LINCOLN CITY/LANCASTER COUNTY PLANNING STAFF REPORT

PROJECT #: Special Permit #06052

PROPOSAL: Special Permit for a Community Unit Plan of approximately 61 acreage lots.

Special Permit #06052 & Change of Zone #06060 West Van Dorn Heights SW. 70th and W. Van Dorn St.

WEST VAN DORN HEIGHTS ASPEN BUILDERS CUP #

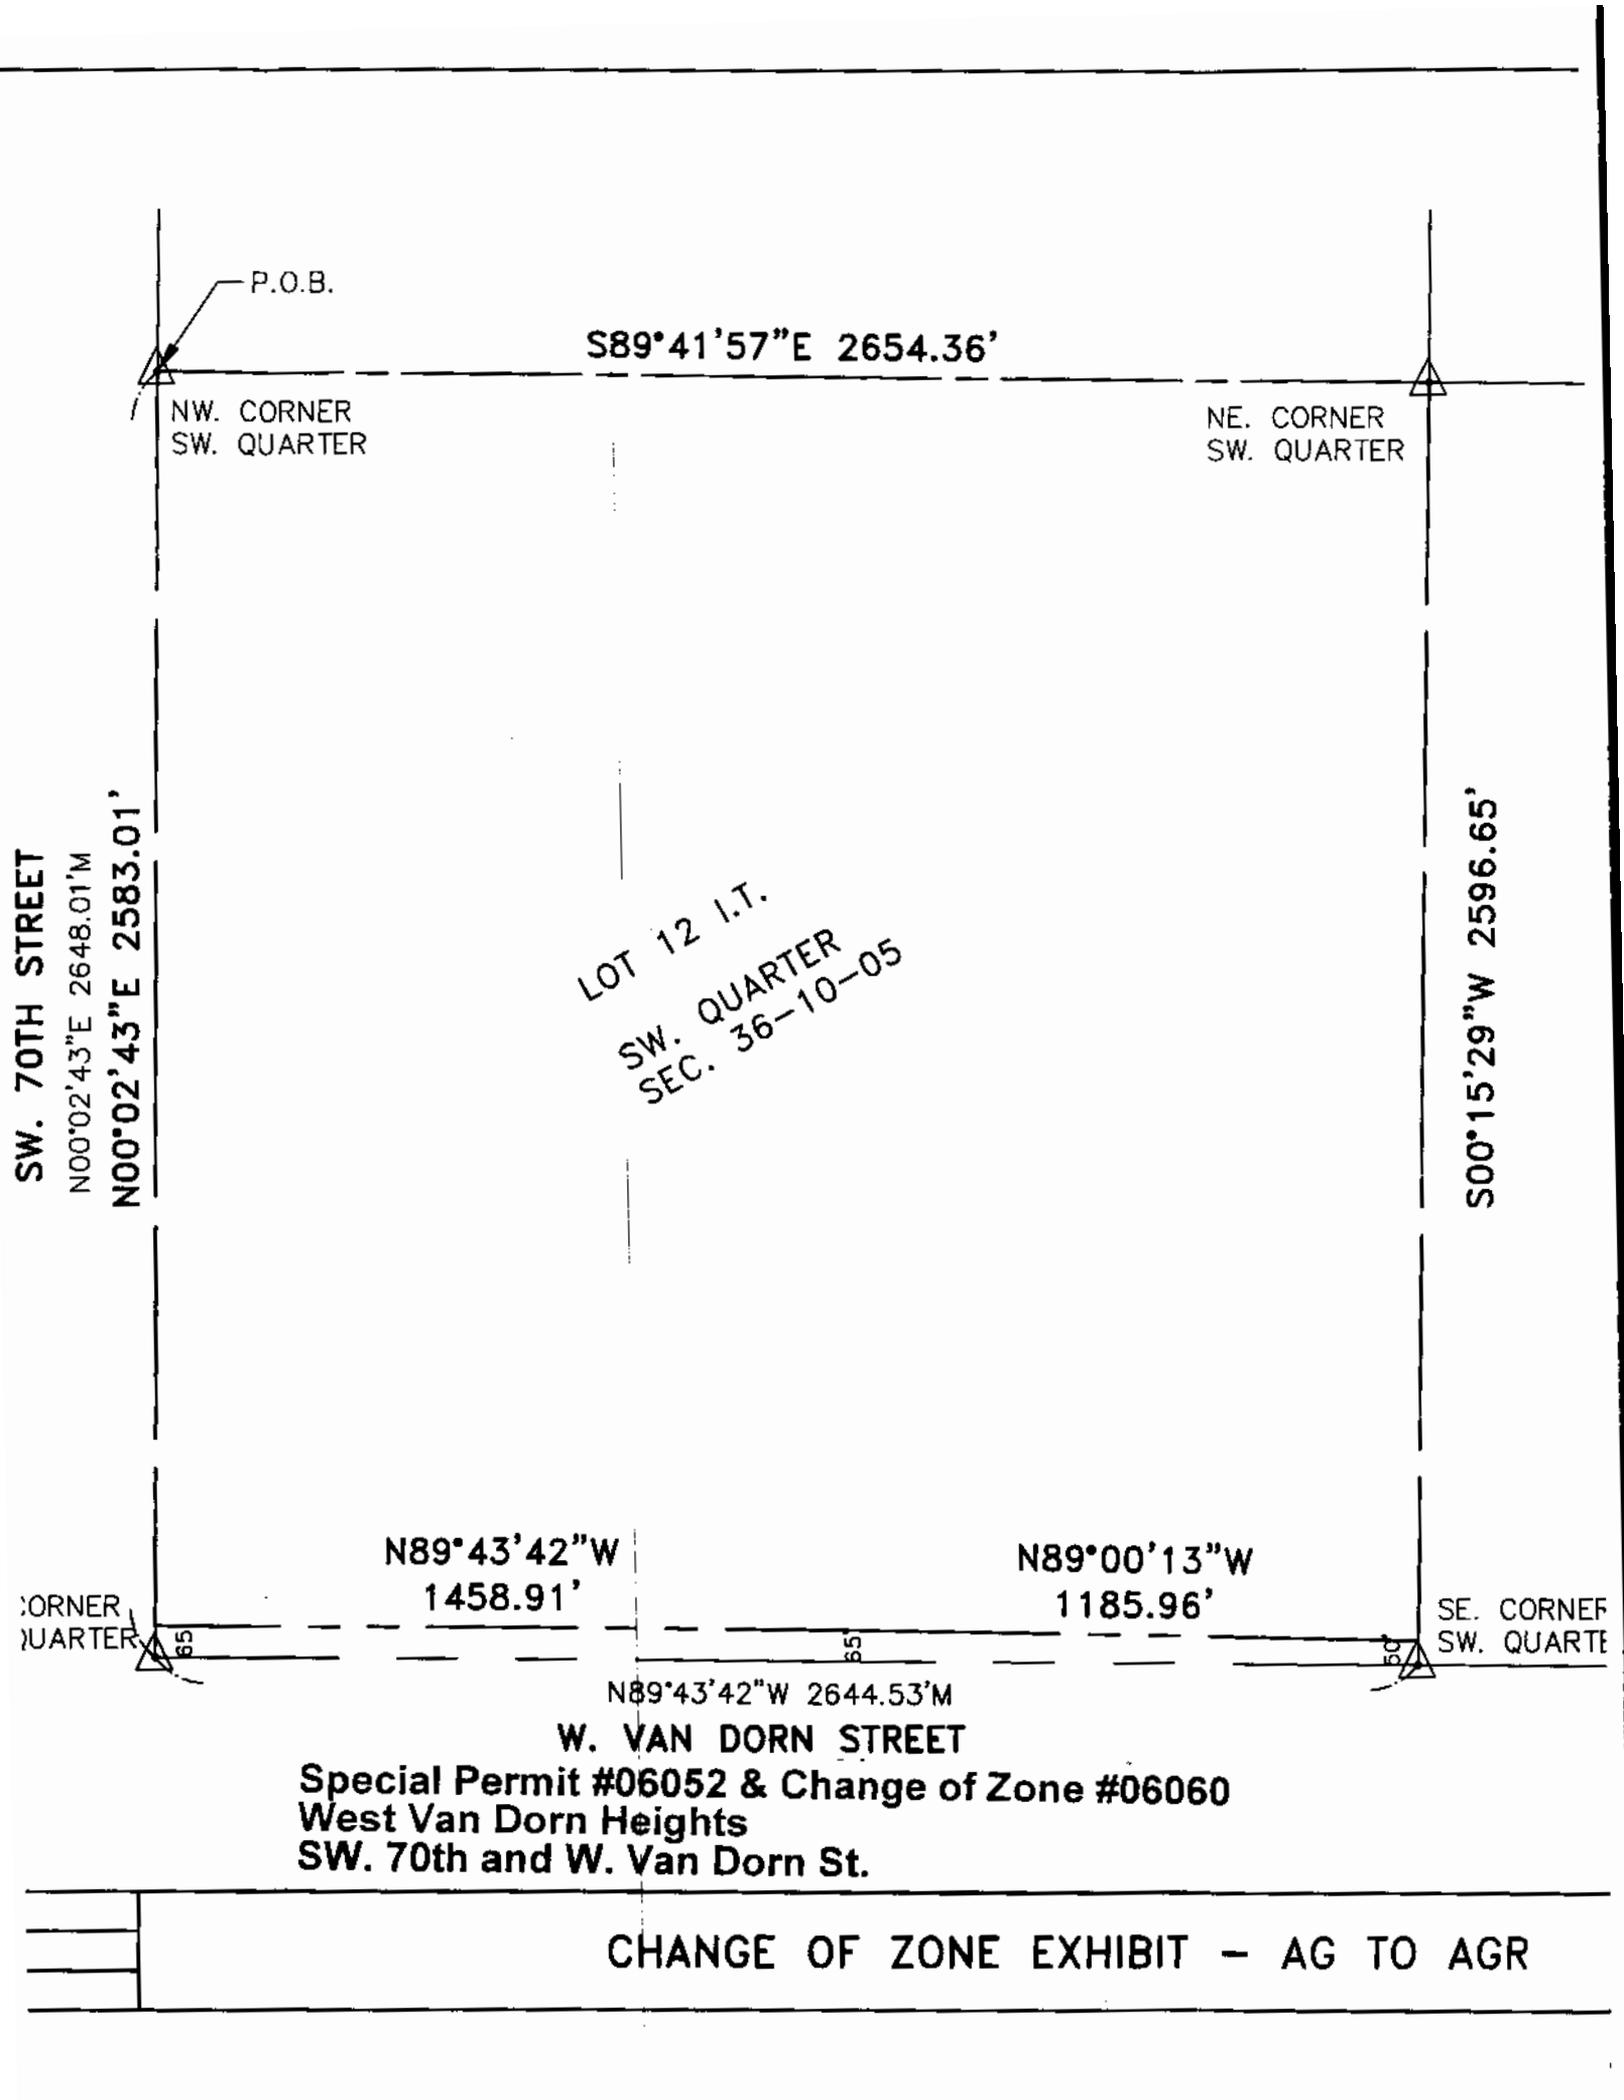
SUBJECT: WEST VAN DORN HEIGHTS
CZ 06060 SP 06052

- 1) West Van Dorn shall be regraded for the left turn lane with 4' shoulders. Details should be shown for the design of the left turn lane.
- 2) Concrete pavement shall be installed as approved by Public Works.

- 3) Developer shall install survey monument boxes at all centerline control points and set centerline control upon acceptance of the paving.
- 4) Developer shall be responsible for transitional grading of SW 70th Street north of West Benelli Lane and RUTS design south of West Benelli Lane. The RUTS design will require additional right-of-way on the west side of SW 70th Street.

- 6) *General Note 32* should be revised since there is no flood plain on the property.
- 7) *General Note 33* is not needed in light of *General Note 19*.

- 8) The end treatments described in *General Note 22* are not required for private drives, but are required for private roadways.
- 9) The notes under the Typical Cross-Section for Rural & Intermediate BTA do not apply.

- 10) The minimum culvert size under the roadway is 24". Culvert 2 and 10 are too small.
- 11) Drainage area hydrology and culvert hydrologys shall be included on the drainage plans.
- 12) The maximum profile grade is 7.0%. The grade of 8.0% on West Hallowell Lane is too steep.
- 13) The approach grade of SW 65th Street (south leg) at West Remington Drive should be 3.0% or less.
- 14) The radius of the returns at NW 70th Street and at West Van Dorn Street shall be 50 feet. Interior returns shall have 30 feet radius.

Comments: Site Plan shows three "future roads" with names Road A, Road B and Road C. We have denied two other developers request for these names and will continue to do so. Lettered streets A through Z are well established and any variation will only lead to confusion and a danger to the Public.

Comments: 65th Street (off of West Van Dorn) should be 66th.

66th Street west of this segment should be 67th Street.

Does West Remington Drive change at the intersection of SW 66th or at the cul-de-sac? Clarify on the plat.
Probably better at the cul-de-sac.

- The easement for the future trunk sanitary sewer needs to be shown along the existing channel.
- The possible future detention areas need to be shown and labeled on the plans. If the existing pond is intended to serve as the future detention cell, this needs to be indicated on the plans.

- The public access easements for the private roadways need to be clearly labeled and dimensioned on the plan sheets.
- The future roads shown on the build through plan need to be labeled with easements or platted as outlots to ensure that these required roads are able to be constructed when the development is further subdivided into urban density.

4.1.1.3 Call out and dimension all easements.

4.1.1.4 Remove the A,B,C designators on future roads.

4.1.1.5 Show future street connections to S.W. 70th and to W. Van Dorn at the ½ mile line.

4.1.1.6 Show and call out all building envelopes.

4.1.1.7 Show the flood pool elevation of the pond.

4.1.1.8 Renumber the lots and blocks per the subdivision ordinance.

4.1.1.9 Show the tree masses to be removed and retained.

4.1.1.12 Show the acreage of the outlots.

- 4.1.1.13 Show easements for future sewer and storm sewer.
 - 4.1.1.14 Amend note on waivers to reflect the preliminary plat.
 - 4.1.1.15 Amend note #7, page 4 that stormwater detention standards are met.

- 4.1.1.17 Show a drainageway, future storm sewer and future sanitary sewer easement along the creek in Outlot "C".
 - 4.1.1.18 Show the dimension of all R.O.W.

- 4.1.1.19 Note where each typical road cross section applies.
 - 4.1.1.20 A permanent final plan with 5 copies as approved.
- 4.1.2 Provide documentation from the Register of Deeds that the letter of acceptance as required by the approval of the special permit has been recorded.
